**King's Mark
Environmental
Review
Team
Report**

**STONEBROOK
SUBDIVISION
COLEBROOK,
CONNECTICUT**

Environmental Review Team Report

MAY 1988

STONEBROOK SUBDIVISION
COLEBROOK, CONNECTICUT
PROPOSED SECTION 1
King's Mark Environmental Review Team

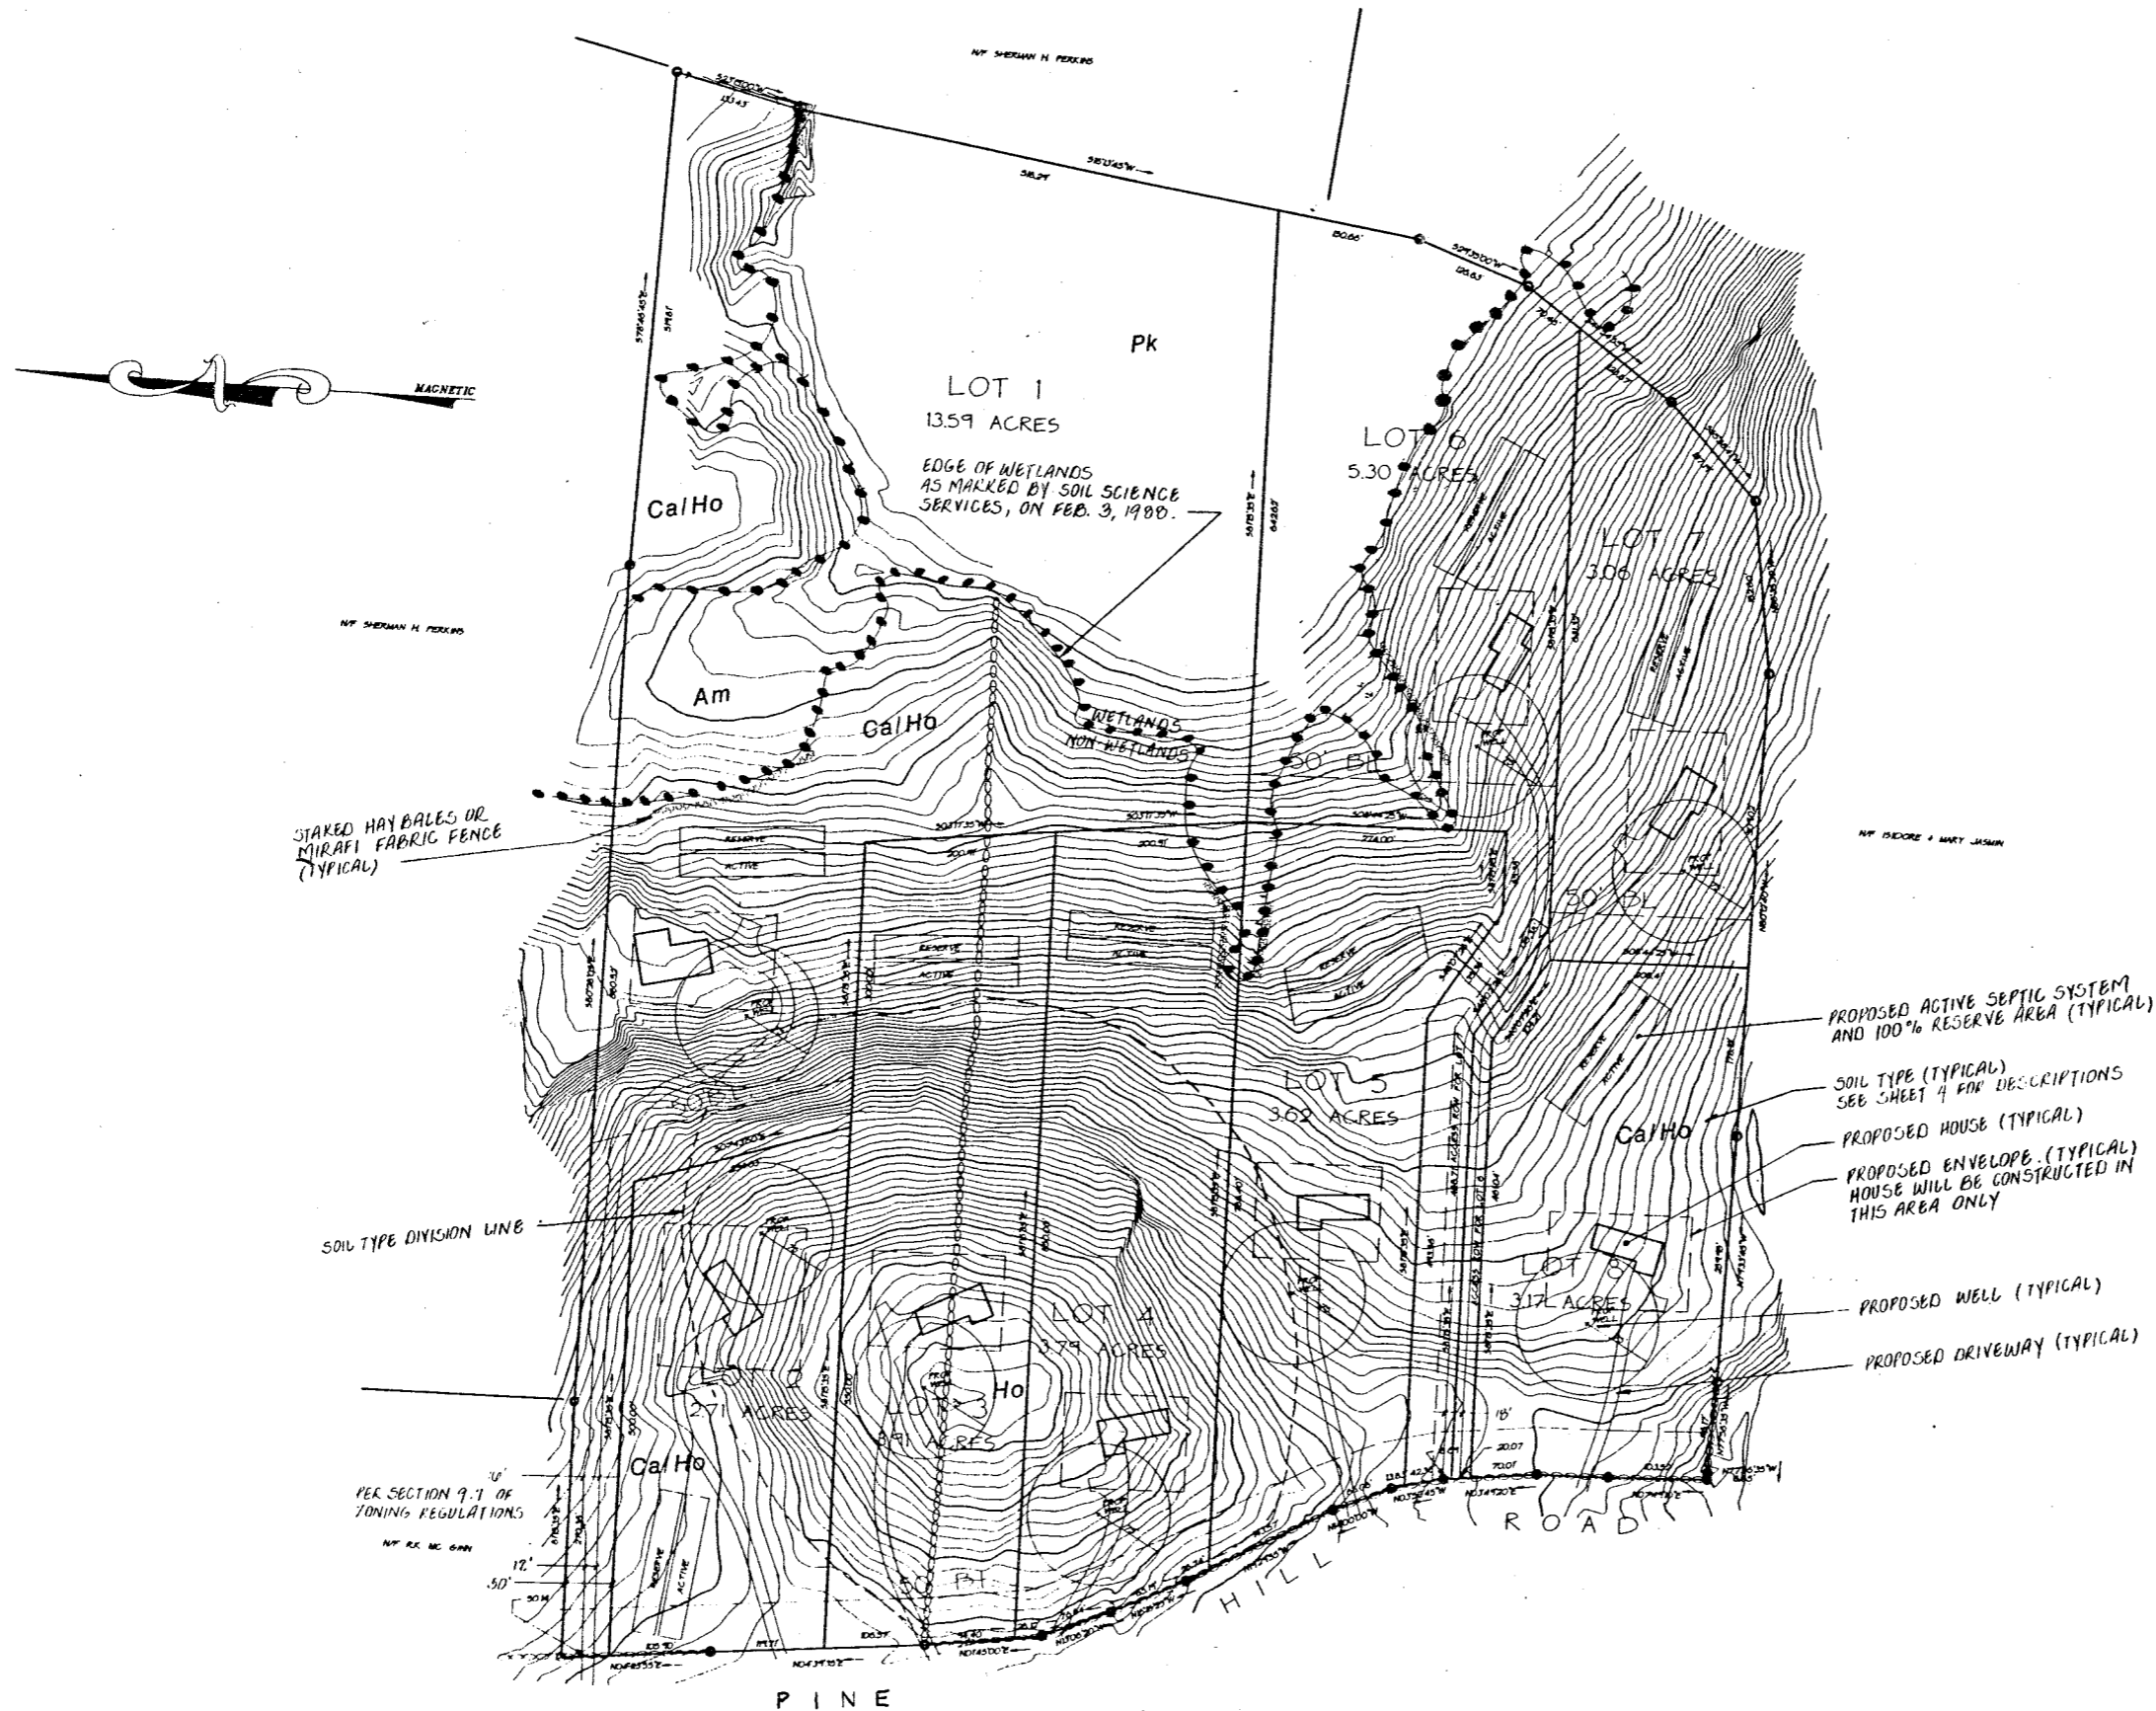
Section 1 is steeply sloped with little soil cover in the western part. Many of the septic systems are located considerable distances from the houses. Both the septic tank and the distribution lines must be constructed so that sewage will not leak onto the bedrock. The soils of the primary and reserve leaching fields appear to be suitable. Each of the lots will require detailed engineering design plans. One concern on Lot 3 is the stone wall which may serve as a conduit for groundwater. Lot 3 is wide enough so that the leaching fields can be moved to avoid the stone wall.

- 1) Lots which have shallow to bedrock conditions, generally 7 feet or less (Lots 2, 3, 4, 5 and 8 in Section 1).
- 2) Areas of moderate to steep slopes (mostly all of Section 1 and the central parts of Section 2).
- 3) The presence of till (hardpan) soils which have moderately slow percolation rates and elevated groundwater table. These two conditions result from the silty and more compact soil zone which develops below the rooted and surficial weathered zone.

Soils in each of the proposed primary and reserve leaching areas appear to be well suited for leaching purposes. Each of the 8 lots will require detailed engineering design plans be prepared due to the shallow depth to bedrock and potential for groundwater to be within 3 feet of existing grade. For that reason, it is highly probable that shallow leaching trench systems will be utilized, incorporating groundwater intercepting drains and some quantity of sandy fill material to assure trench bottoms are placed at least 18 inches above the compact glacial till. One other concern with respect to Lot 3 is the location of the stone wall which runs perpendicular to existing contours. In the past, stone walls have been known to intercept and carry subsurface groundwater flows, acting very much as a curtain drain. Fortunately, Lot 3 is wide enough so that the primary and reserve areas could possibly be located north of the wall and not require its disturbance or removal. It is highly probable that additional deep test pits and percolation tests will be performed with respect to individual designs of sewage disposal systems serving the proposed residences.

**PROPOSED
SECTION 2**

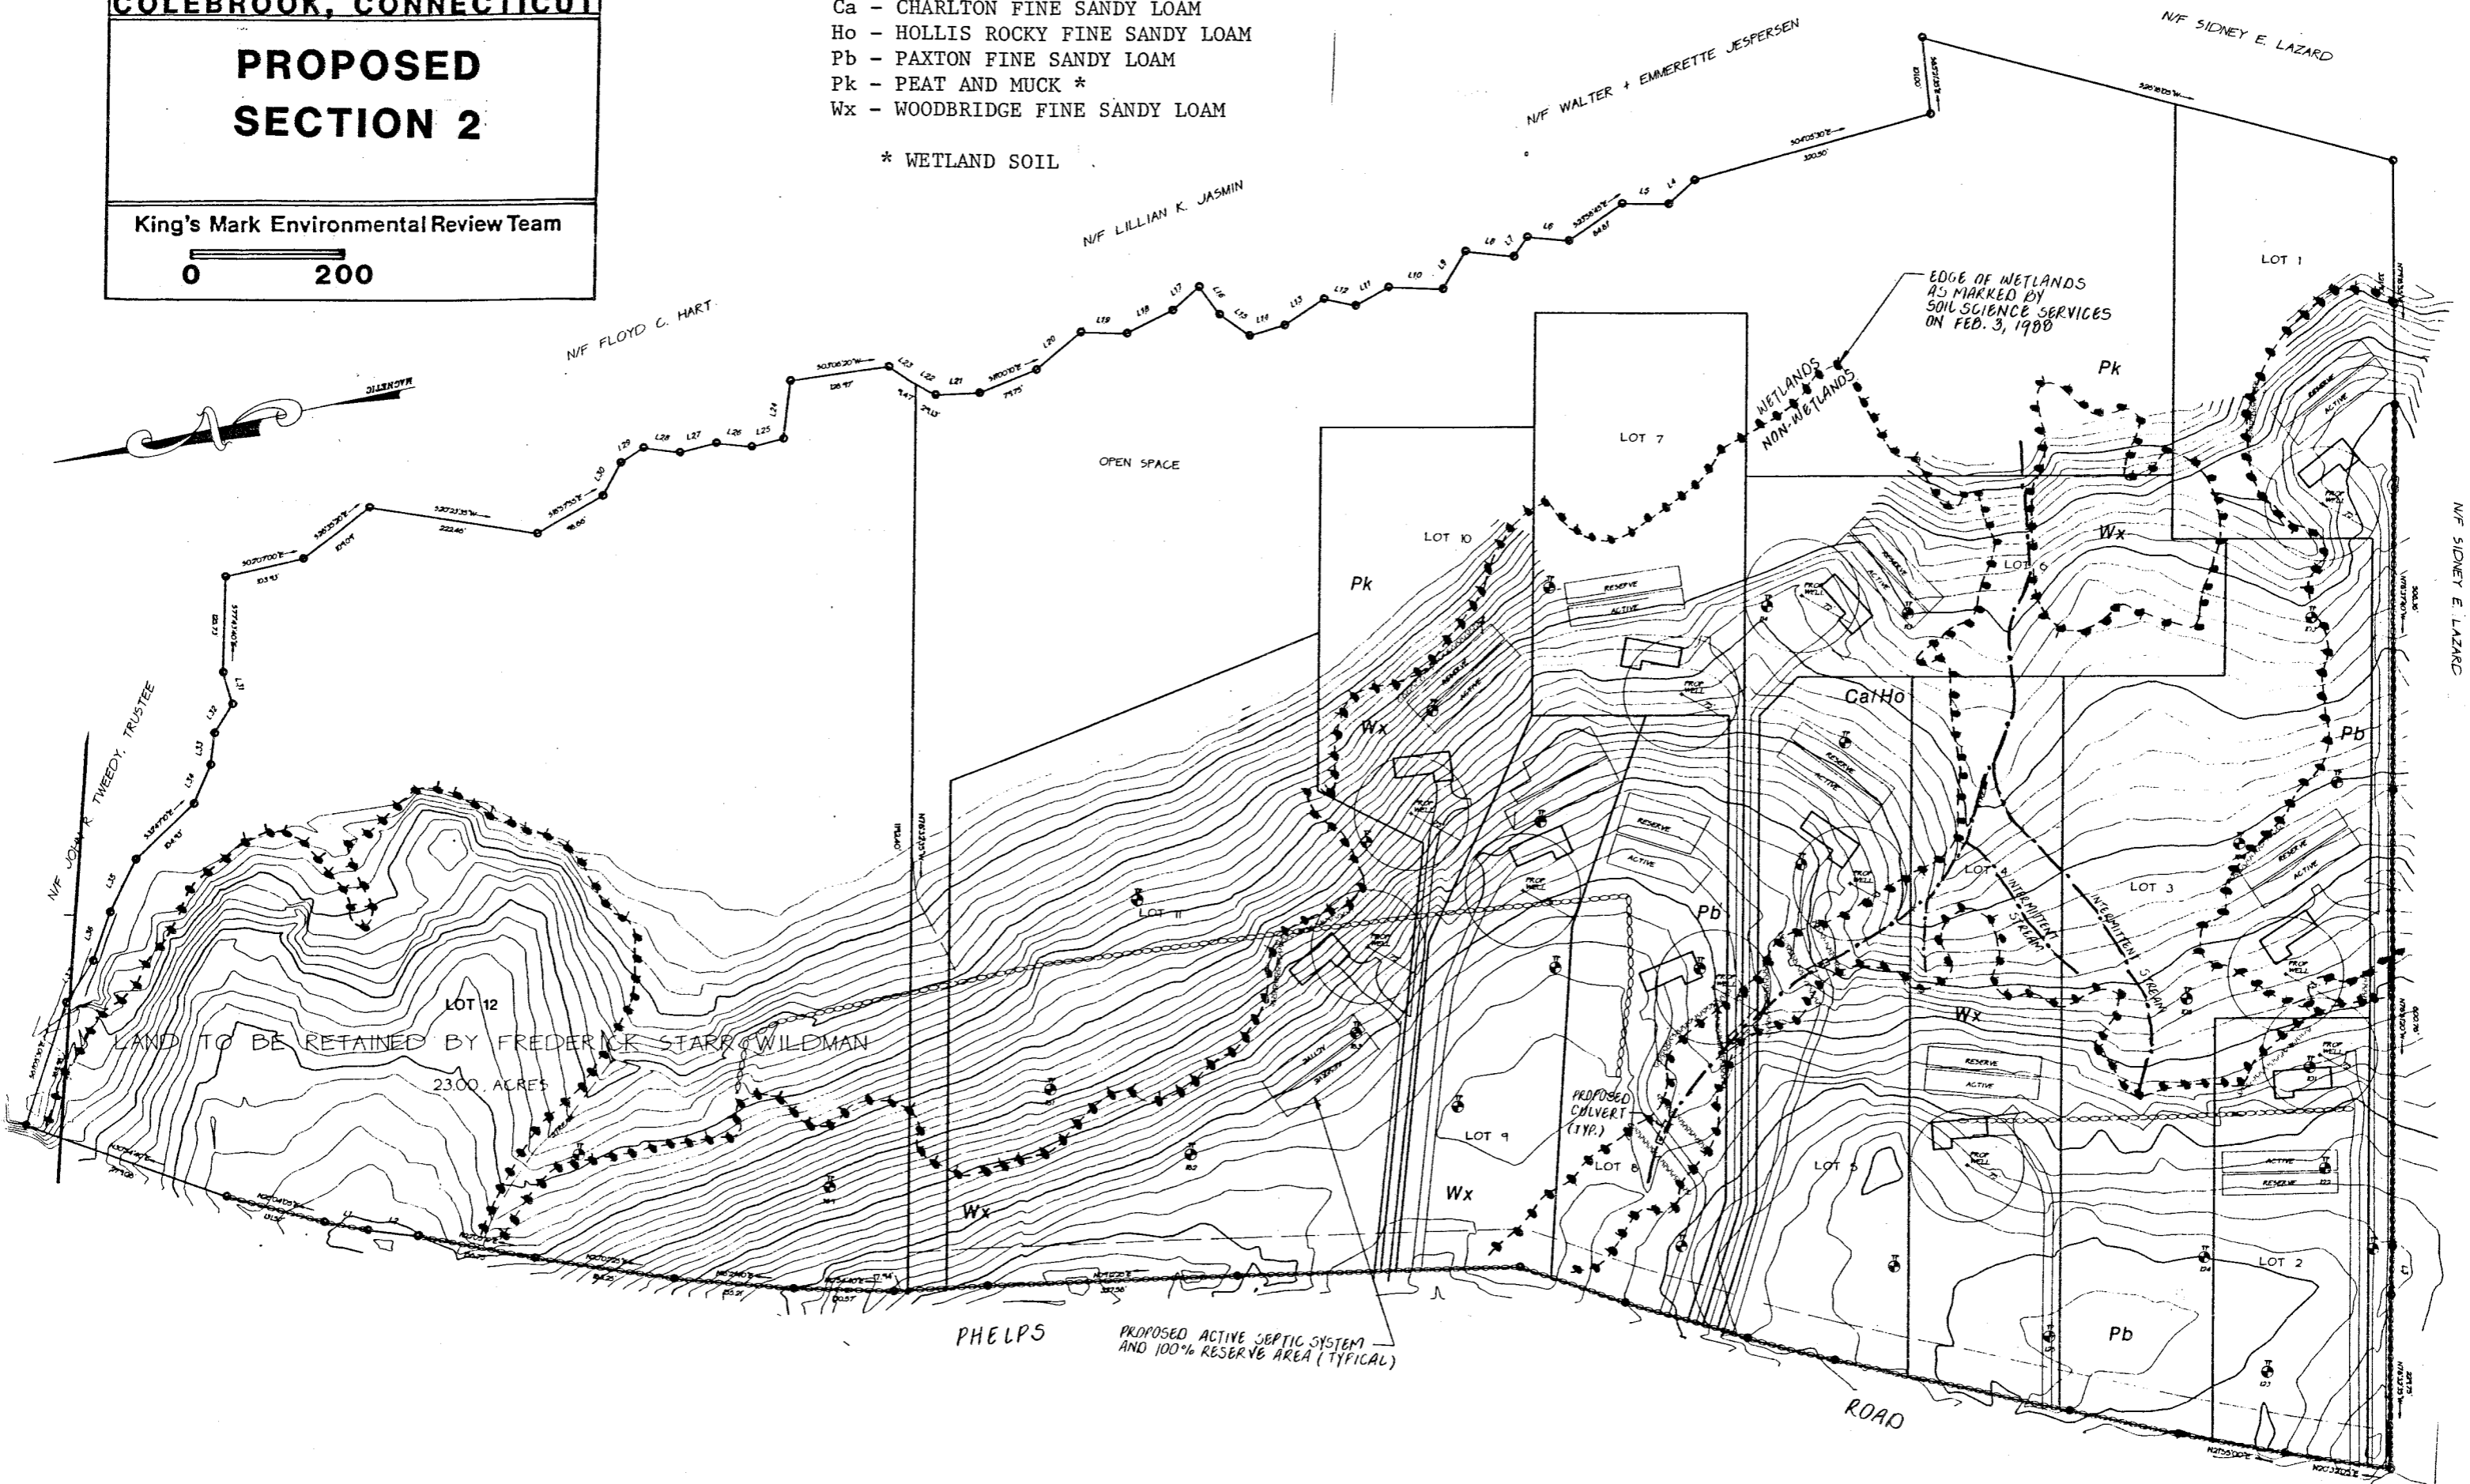
Section 2 does not have ledgerrock as the restrictive factor. The soils should be suitable for leaching fields. The major restrictive factor is the seasonal high groundwater and the proximity of the wetlands. Two of the houses will have the sewage pumped. Proper design of the septic systems should assure no adverse impacts to the wetlands. Detailed engineering plans will be required for many of the lots due to high groundwater level.

- 1) A reduction of the number of lots which would reduce the number of crossings required to access the property, and/or
- 2) Reducing the number of crossings from four to two. One crossing to access Lots 1, 2 and 3 and one combined crossing to provide access to lots 5, 6, 7 and 8.

- 3) The driveway layout for Section 2 is less than optimal due to the number of curb cuts in close proximity to one another. This presents a potentially unsafe situation where vehicles could conflict with one another in turning movements. A system of shared driveways, private roads or new town roads should be considered to improve the current plan. Shared driveways may be appropriate for Lots 1, 2 and 3, 5 and 6, 7 and 8. If Colebrook's zoning regulations were amended to provide for private dirt roads (e.g. through a special permit process where meaningful open space land was provided as a trade off), a private dirt road might be appropriate to service Lots 5, 6, 7 and 8. Use of a private dirt road might also be appropriate to service Lots 9, 10 and 11. Barring provisions for private dirt roads, consideration should be given to serving Lots 5, 6, 7 and 8 plus 9, 10 and 11 with paved private roads or local roads as provided for under Colebrook's subdivision regulations.

Based upon review of all of the information provided, each of the proposed 12 lots should be considered suitable with respect to minimum Public Health Code requirements for installation of a subsurface sewage disposal system. Due

to the groundwater elevations noted, each of the 12 lots would be classified as an area of special concern and require detailed engineering plans be prepared by a registered professional engineer. It is quite possible that designated leaching areas will be shifted slightly and that additional soil tests will be performed in order to identify the suitability of the final designated primary and reserve leaching areas. The engineering plans should also address the details and technical complexities of pumping effluent to higher leaching areas serving those residences on Lots 2 and 11.
